MISSISSIPPI RIVER MAINLINE LEVEES ENLARGEMENT AND SEEPAGE CONTROL

SUPPLEMENT NO. 1 TO THE
FINAL ENVIRONMENTAL IMPACT STATEMENT
MISSISSIPPI RIVER AND TRIBUTARIES PROJECT
MISSISSIPPI RIVER LEVEES AND CHANNEL IMPROVEMENT

APPENDIX 5
PUBLIC INVOLVEMENT AND COORDINATION

No.	Title
A	PUBLIC INVOLVEMENT AND COORDINATION
B	RESPONSES TO DRAFT REPORT AND DRAFT SEIS COMMENTS
C	TRANSCRIPTS OF PUBLIC MEETINGS

Figure 2. Location of proposed mitigation land for purchase as addition to Donaldson Point CA, prioritized 1-4.

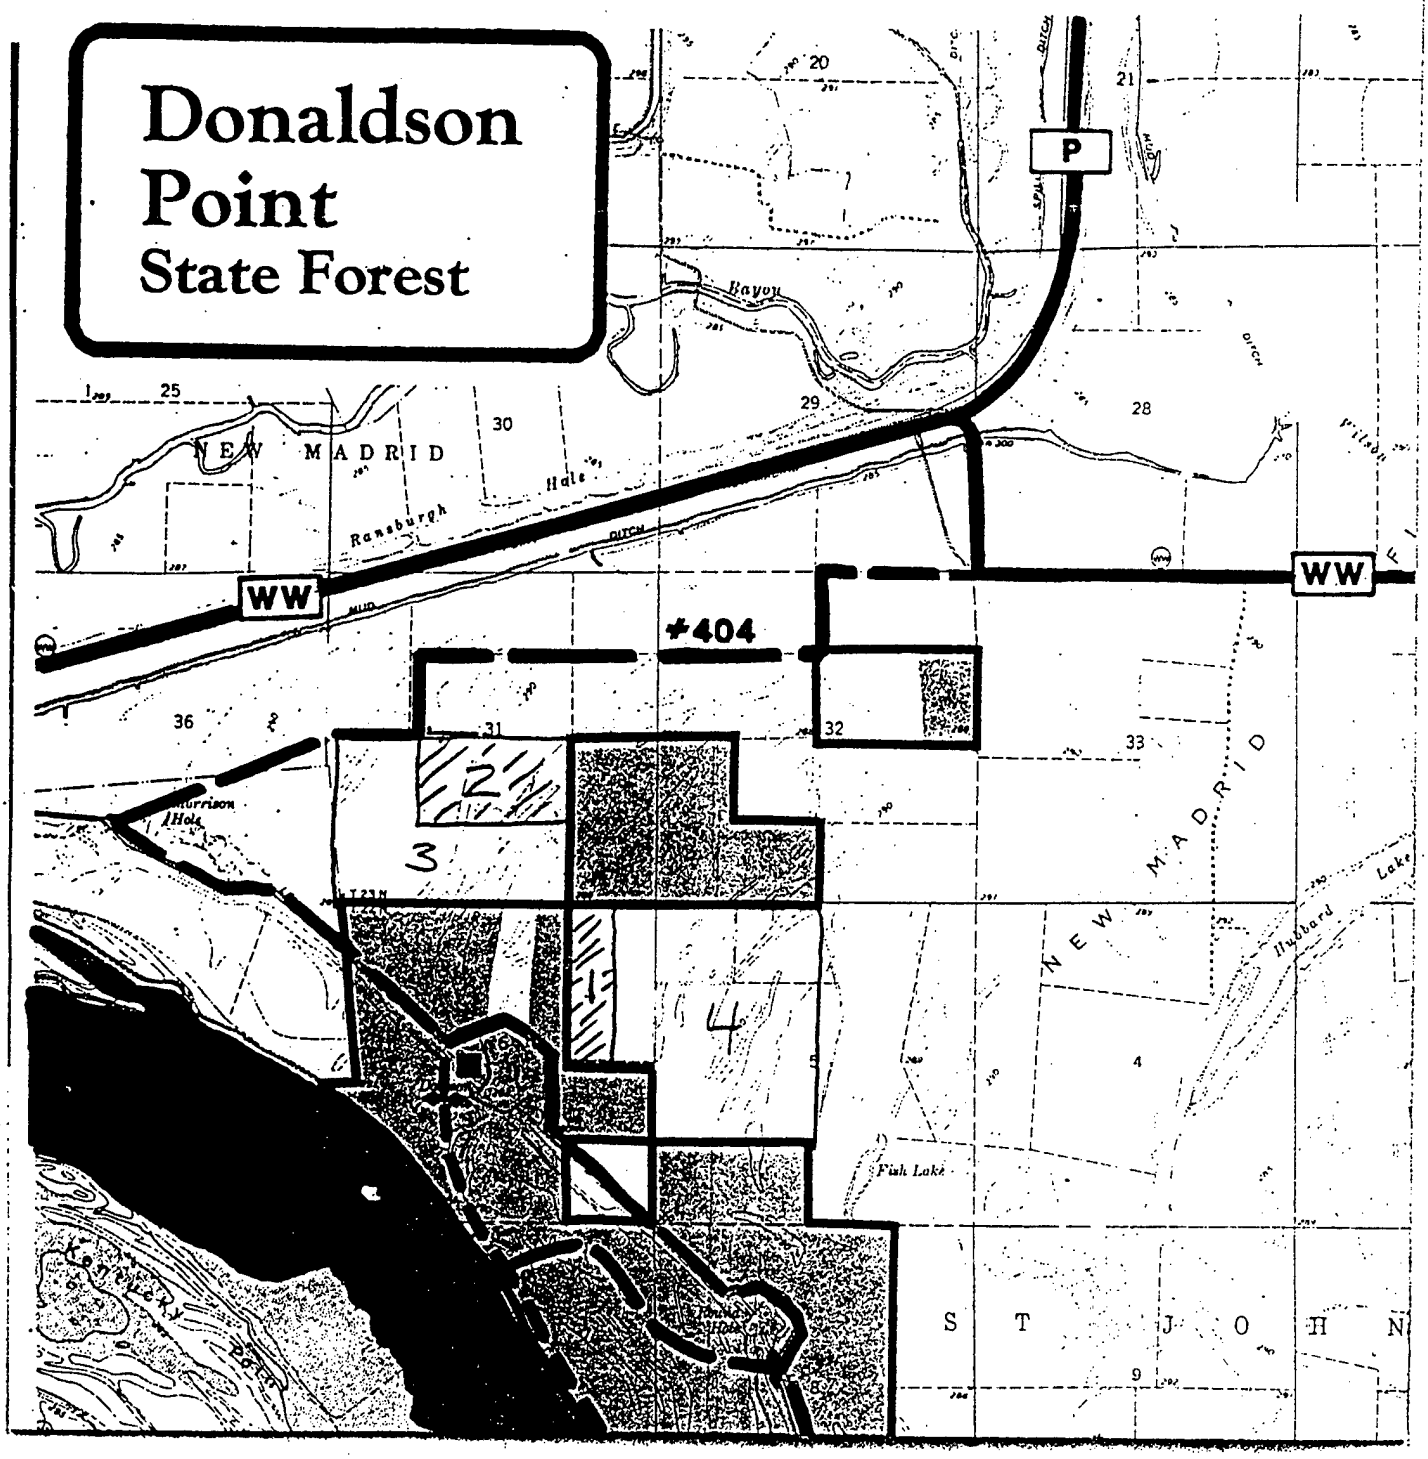
If bottomland hardwoods or wetlands are destroyed because of berm construction, we request mitigation of losses. Land for mitigation, as prioritized 1 through 4 in Figure 2 (attached), should be purchased adjacent to Donaldson Point CA. Area 1 (40 acres) contains old-growth cypress trees; area 2 (80 aces) contains existing bottomland hardwoods; while sites 3 (160 acres) and 4 (280 acres) are agricultural land that could be replanted to hardwoods. Addition of these in-holdings would help consolidate the Donaldson Point CA.
